Tuesday, December 14, 2021
Medway Planning and Economic Development Board
155 Village Street
Medway, MA 02053

ROCKY'S HARDWARE – 98 MAIN STREET – ADMINISTRATIVE SITE
PLAN AND OUTDOOR DISPLAY SPECIAL PERMIT – Public Hearing
Continuation

PUBLIC HEARING - MULTIFAMILY DEVELOPMENT SPECIAL PERMIT, MAJOR SITE PLAN APPROVAL AND LAND DISTURBANCE PERMIT for 6 CUTLER STREET:

SHEET 3 OF 4

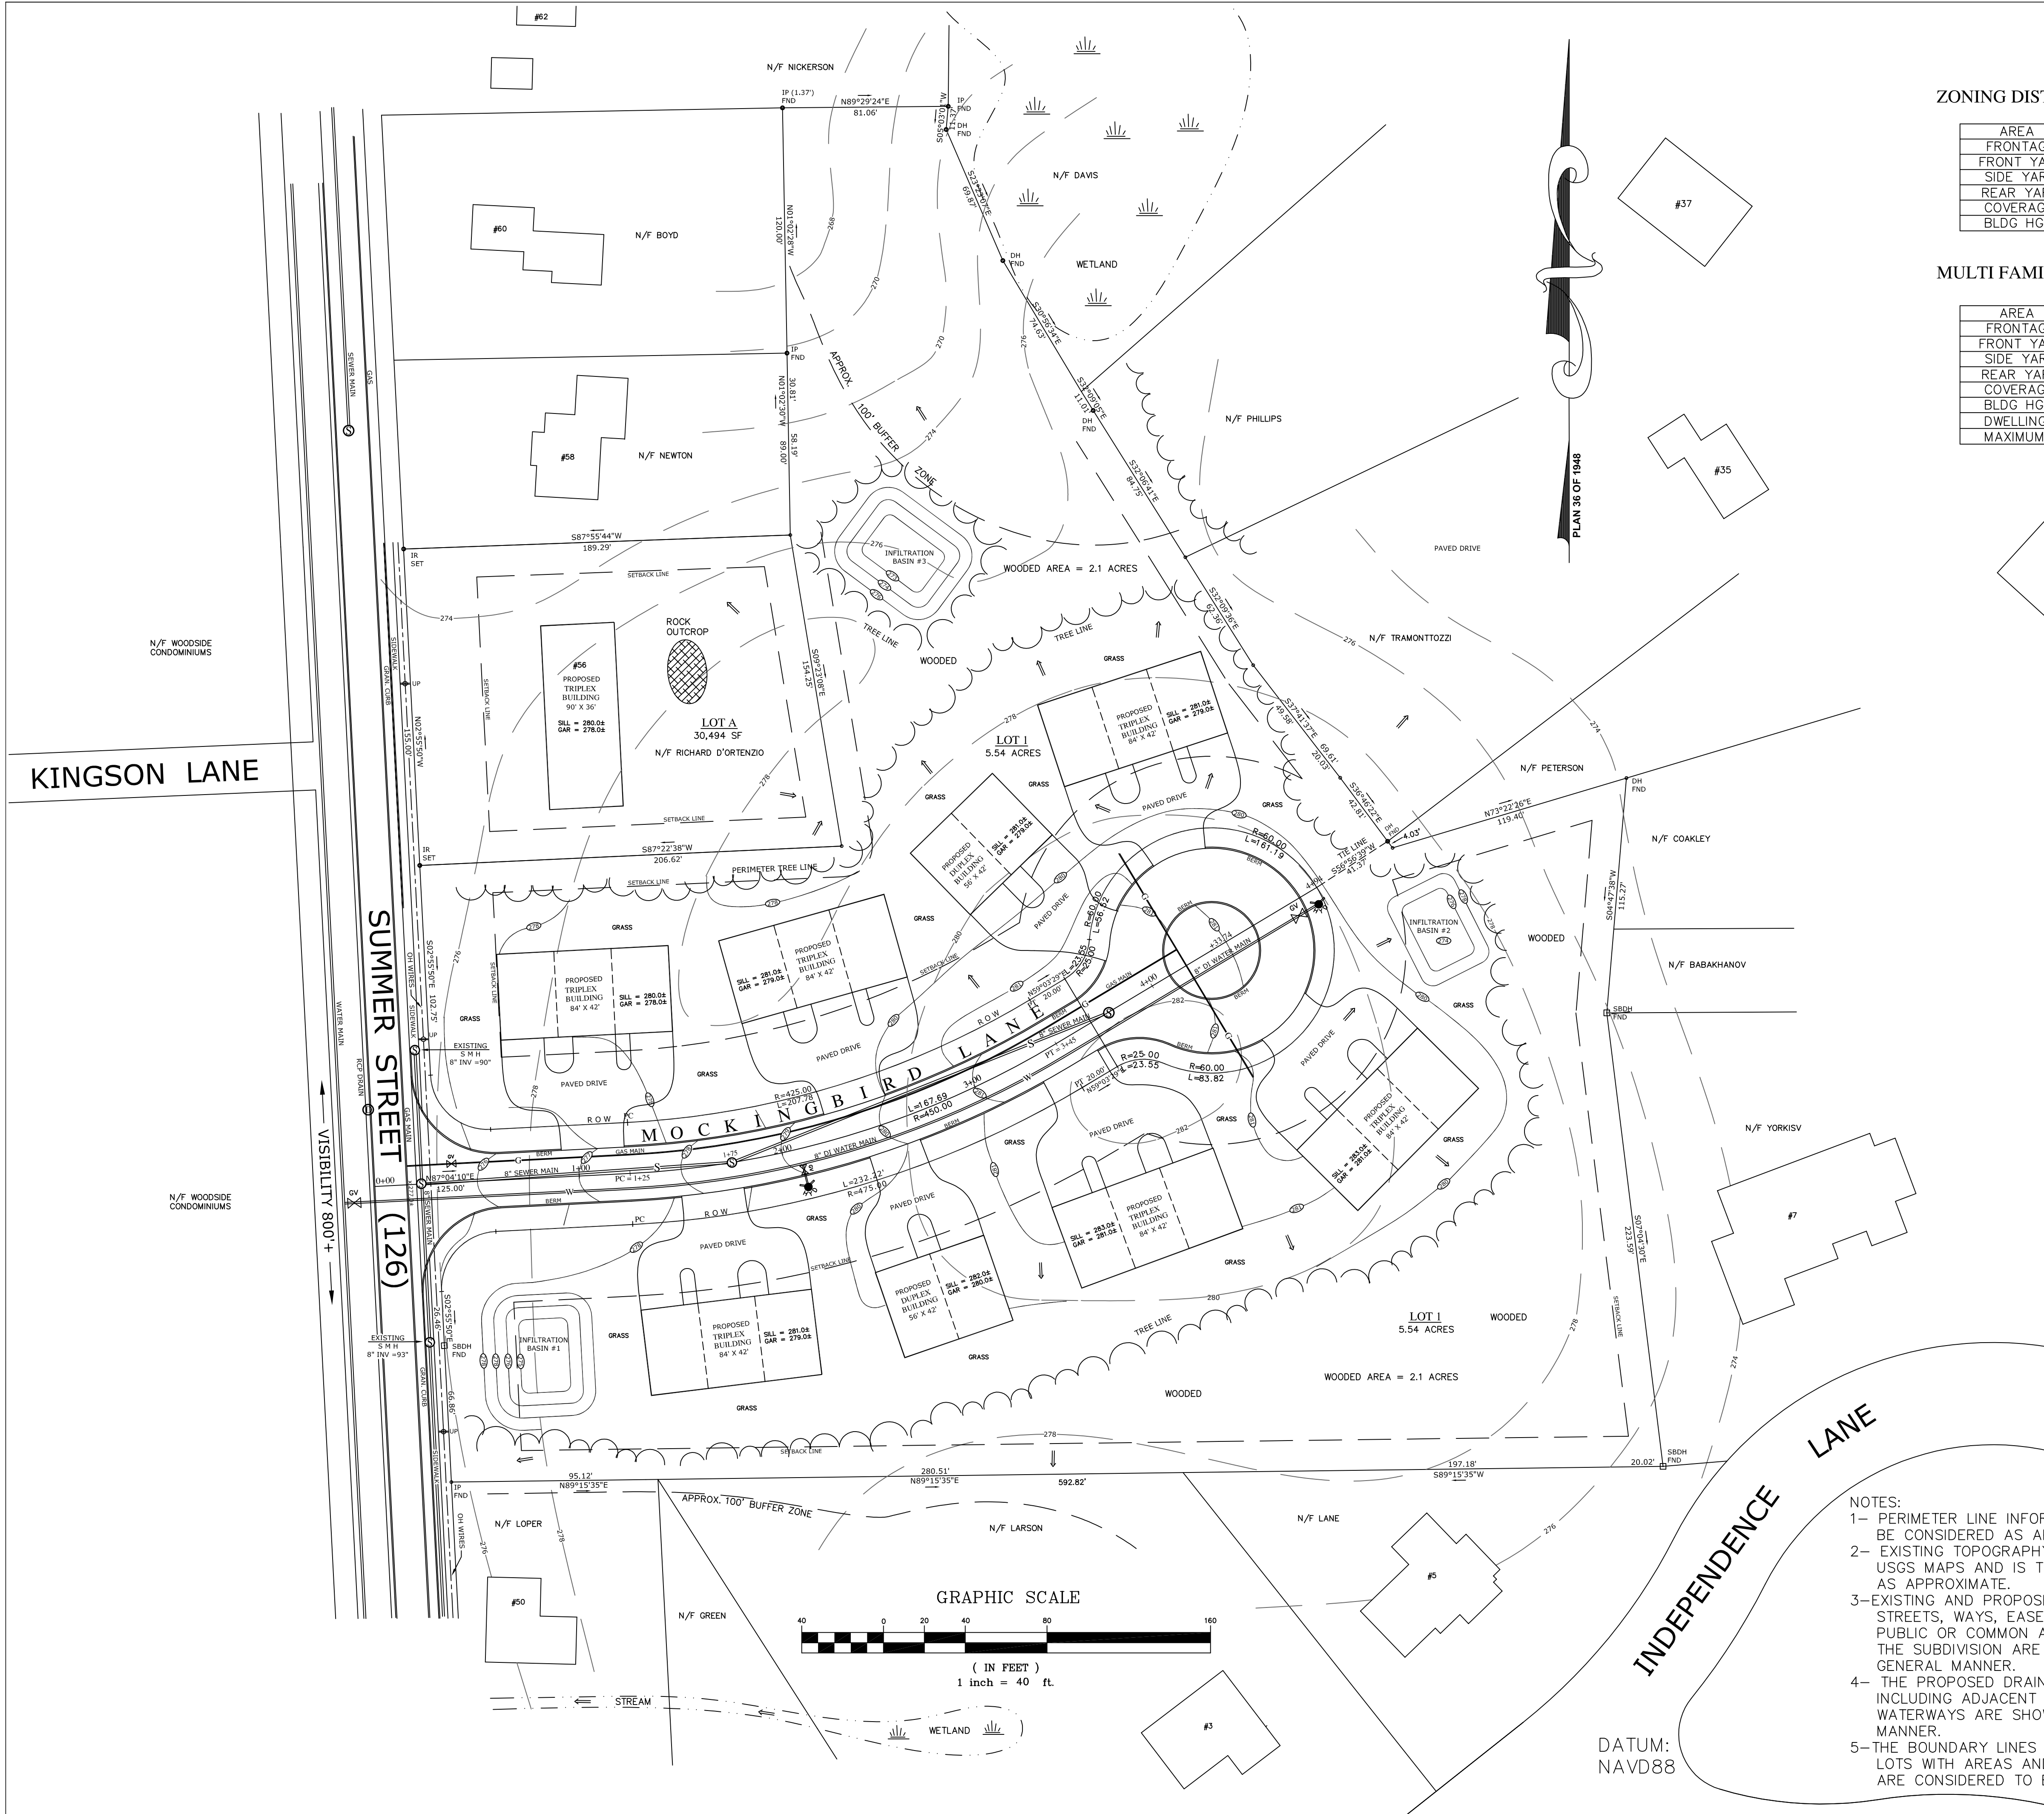
5. On sheet 3 of 4 of the plans the elevation line that goes through the basement of my home at 7 Independence Lane, which has a walkout basement, is 274 which is the same elevation proposed for the bottom of infiltration basin # 2. For the official record of the PEDB, since my wife and I have lived at 7 Independence Lane we have never had water in our basement and have never had standing water in our backyard.

6. On sheet 3 of 4 of the plans show infiltration basin # 3 in a wooded area. It is disingenuous to show the proposed basin surrounded by woods because trees will need to be removed to create the basin, to install the piping that will connect to the basin, and to provide a permanent access to the basin for maintenance purposes.

PROPOSED STREET LIGHT

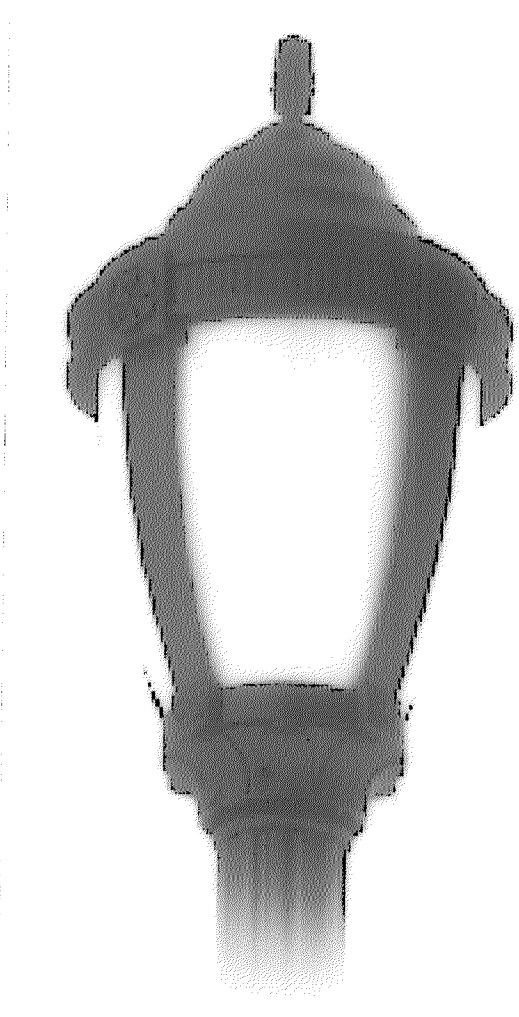
Suzy, After reviewing the light posts with the lighting expert at Fergusons, she indicated that the proposed post lights are for a commercial application and would be too bright given the lumens output. She indicated that type of light is typically seen on much taller posts for street lighting or parking lots. Given that there is a street pole light at entrance to subdivision and parking lights from abutting property as well as 2 lights over each garage door and the front door, any more lighting might be excessive.

The only other recommendation if the planning board wanted to keep the post lights would be to make them dark sky lights at the proposed location at the end of the walkway which is what is commonly used.
